March 15, 1983

W3P83-0844  
3-A1.01.04  
Q-3-P43

Subject Louisiana Power & Light Company  
Waterford SES Unit No. 3  
Docket No. 50-382  
Installation of Fire Protection  
Envelope for Class IE Electrical Cables  
Use of the Insulco/HEMYC System

ATTACHMENT I

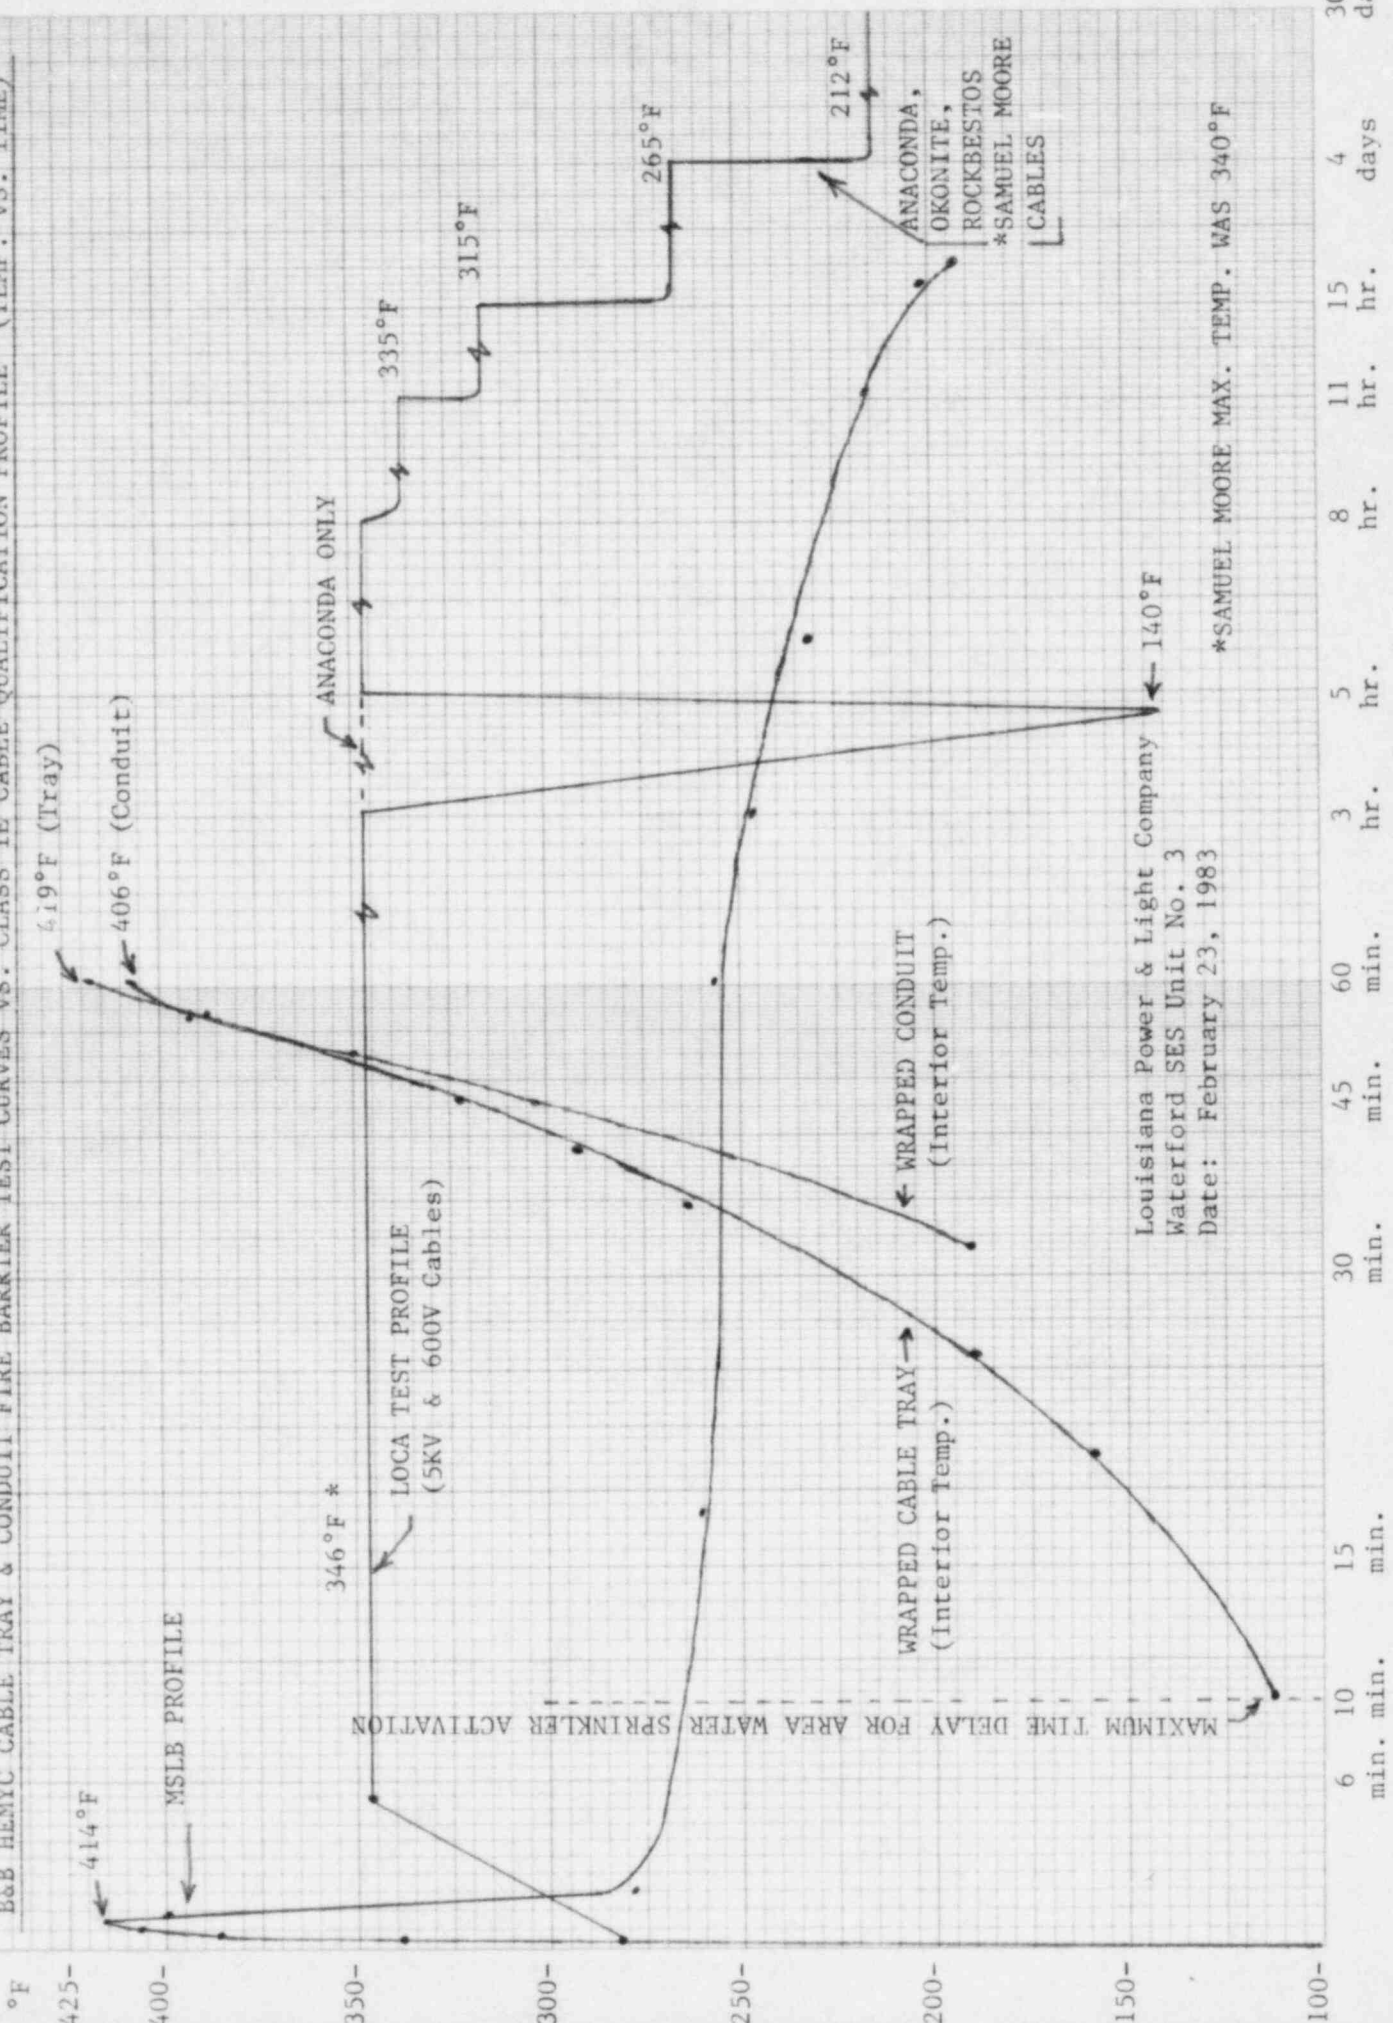
1. What affect would energizing the tested cable, with anticipated service voltage, have on the results of the fire qualification test?, and
2. What justification could be provided for the maximum tray and conduit temperature of 419°F and 406°F, respectively?

- a. As indicated by the temperature profile (reference attachment 1), the temperature during environmental testing exceeds the corresponding fire qualification temperature, for time = 0 to 50 minutes. The LOCA/MSLB temperature profile continues beyond the one (1) hour mark for an extended period of time. Typical temperature/time are listed below:

It is obvious from the above description, and as illustrated on attachment 1, that the environmental qualification test provides a harsher environment than experienced during the first 40 minutes of the HEMYC fire test. The results of the environmental qualification test, which utilized preconditioned-fully energized cable, indicates that at temperatures as high as 346°F the tested cables were capable of performing their intended function. At temperatures greater than 346°F the environmental qualification test condition does not fully envelope the HEMYC fire test. However, the HEMYC tests do reveal that the PE/PVC cable tested (a lower quality than IEEE-383 cable), maintained circuit continuity; and that the insulation resistance remained well above acceptable values, subsequent to the one (1) hour fire test.

- . The LOCA qualification curve envelopes the fire qualification test conditions for the first 50 minutes of testing, and accounts for energizing the cables to full voltage.
- . The temperature excursion, which occurred, during the last 10 minutes of the HEMYC test, should not be considered a probable occurrence in the unlikely event of a fire.
